**THE PORT AUTHORITY OF NEW YORK AND NEW JERSEY
TWO MONTGOMERY STREET - 1st FLOOR
JERSEY CITY, NJ 07302**

ADDENDUM NO. 10

TO PROSPECTIVE BIDDERS ON CONTRACT **EWR-154.395** – NEWARK LIBERTY INTERNATIONAL AIRPORT – TERMINAL A REDEVELOPMENT PROGRAM BRIDGES N61, N62, N63, AT-GRADE ROADWAYS AND APPURTENANCES AND CONTRACT **EWR-154.395M** – NEWARK LIBERTY INTERNATIONAL AIRPORT – AGREEMENT TO PERFORM LANDSCAPE MAINTENANCE

SKETCH SK-C01
 ADDENDUM NO. 10

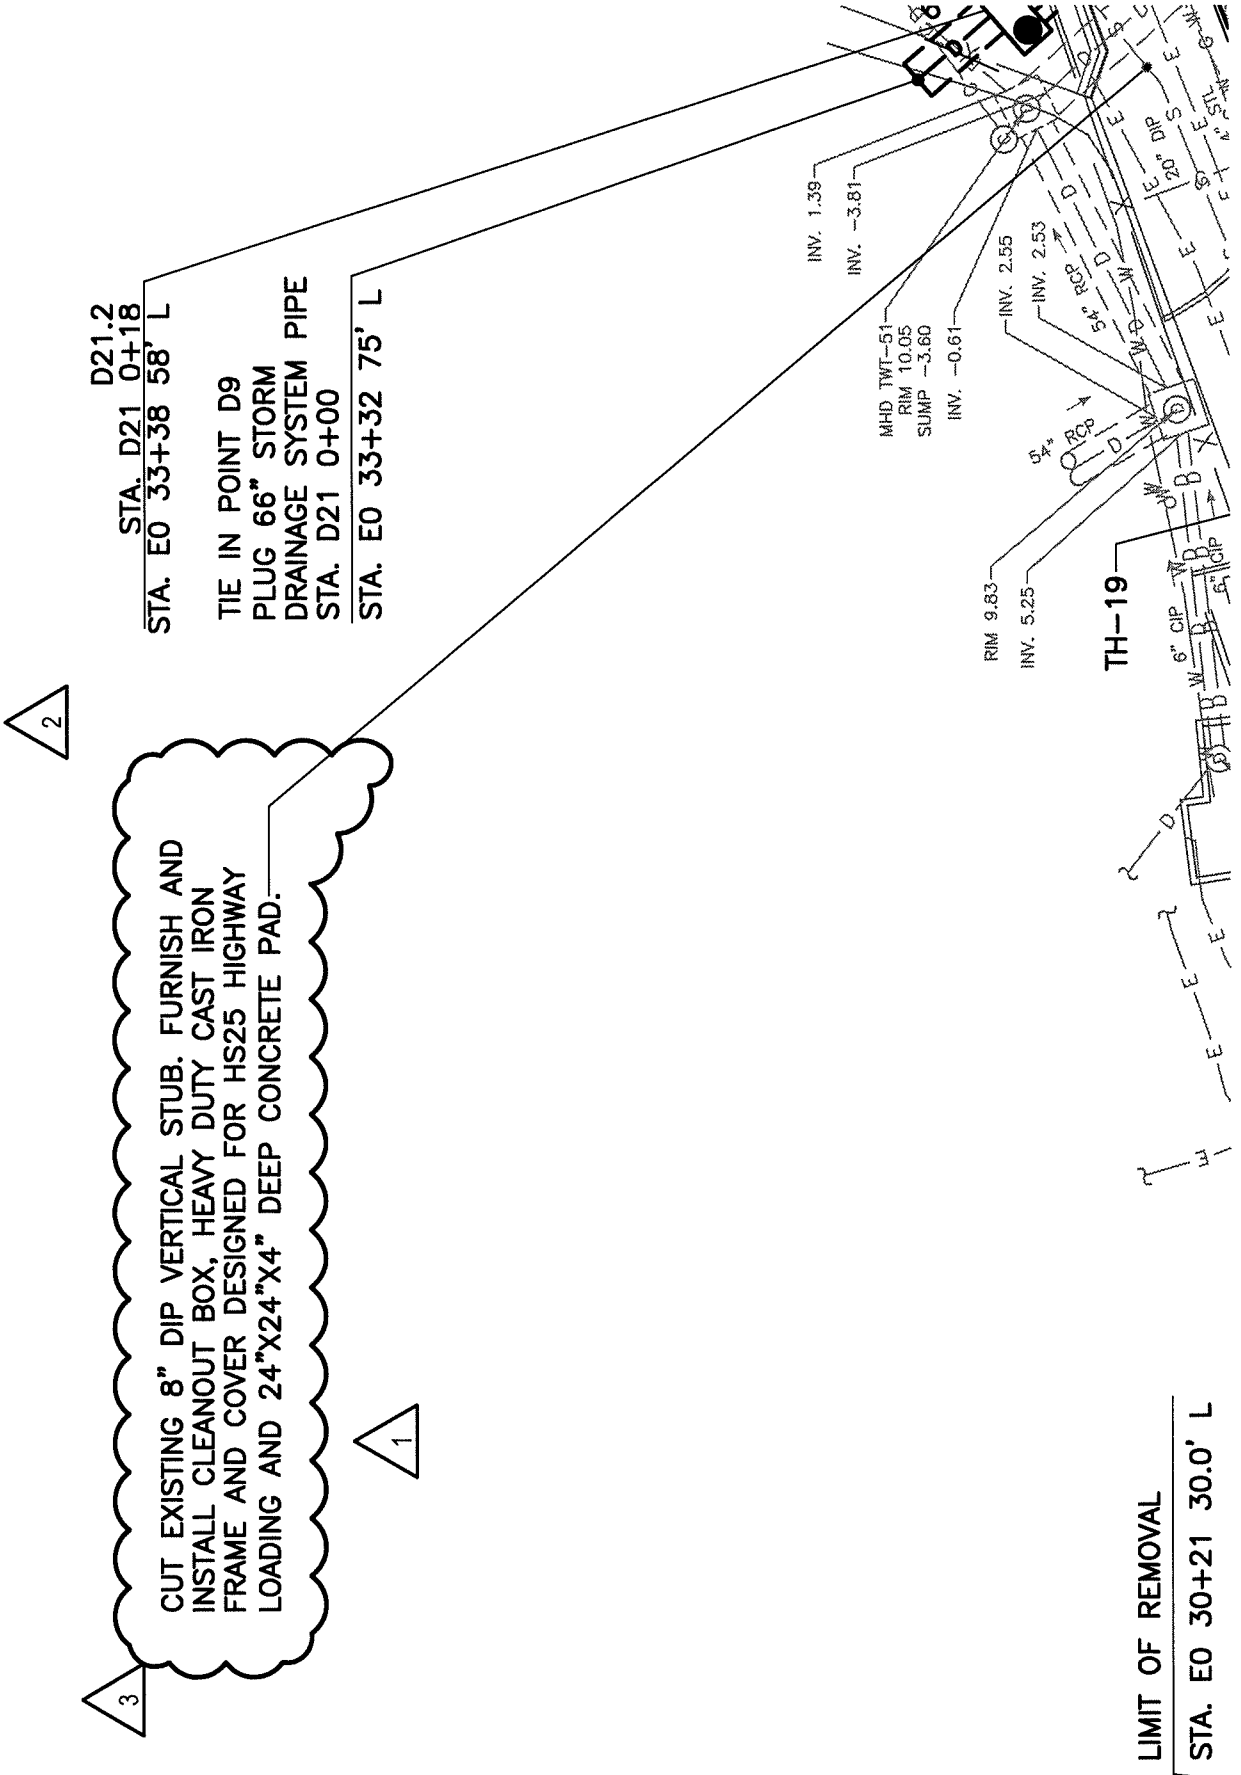
- Dwg. C2105 - Revise the drawing as shown in Sketch SK-C01 which is attached hereto and made a part hereof.
- Dwg. C5108 - Revise the drawing as shown in Sketch SK-C02 which is attached hereto and made a part hereof.

SKETCH SK-S01
ADDENDUM NO. 10

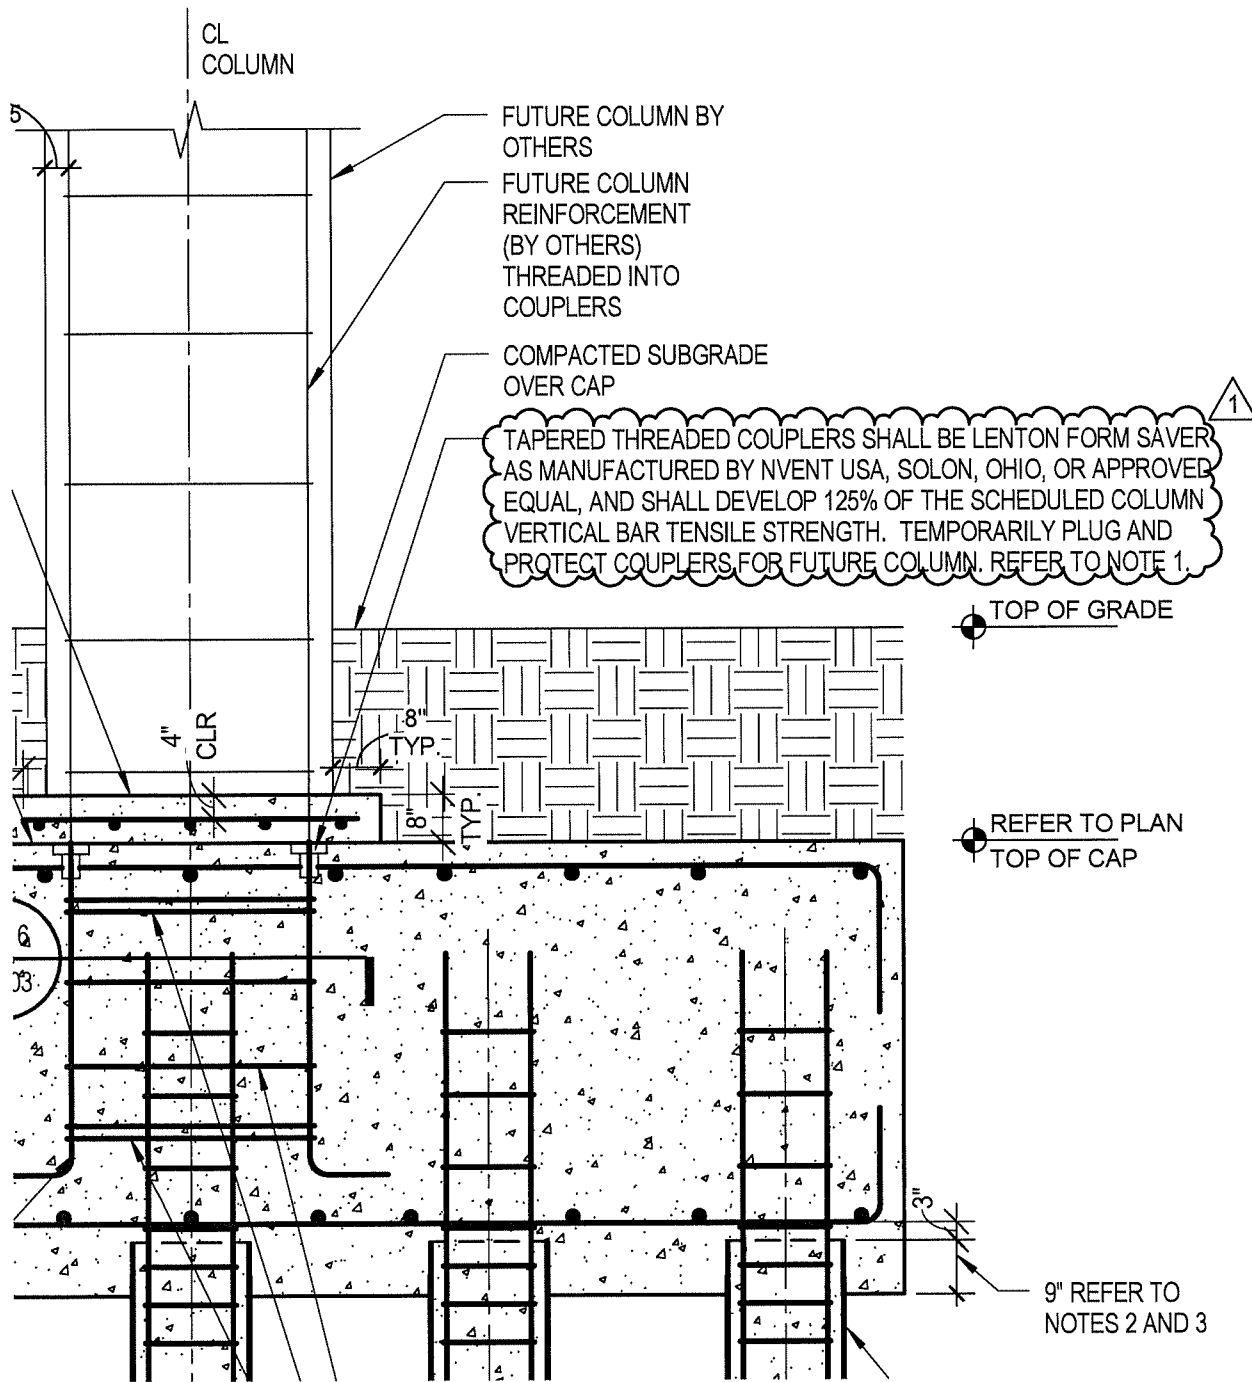
- Dwg. S1403 - Revise the drawing as shown in Sketches SK-S01 and SK-S02 which are attached hereto and made a part hereof.
- Dwg. E0108 - Revise the drawing as shown in Sketches SK-E01, SK-E02 and SK-E03 which are attached hereto and made a part hereof.
- Dwg. E0303 - Revise the drawing as shown in Sketches SK-E04, SK-E05 and SK-E06 which are attached hereto and made a part hereof.
- Dwg. E0304 - Revise the drawing as shown in Sketches SK-E07, SK-E08, SK-E09 and SK-E10 which are attached hereto and made a part hereof.
- Dwg. E0801 - Revise the drawing as shown in Sketch SK-E11 which is attached hereto and made a part hereof.
- Dwg. GT0601 - In the first line of Note 2.1, immediately following "EXISTING" insert "BRIDGE AND".

NOTE 4 REFER TO S1401 AND S1402 DETAILS FOR SIZE, THICKNESS AND REINFORCING

1 COLUMN DOWELS WITH STANDARD HOOKS (OR LENTON BAR TERMINATOR AS MANUFACTURED BY NVENT USA SOLON, OHIO OR APPROVED EQUAL) SUPPORTED ON CAP BOTTOM REINFORCEMENT.
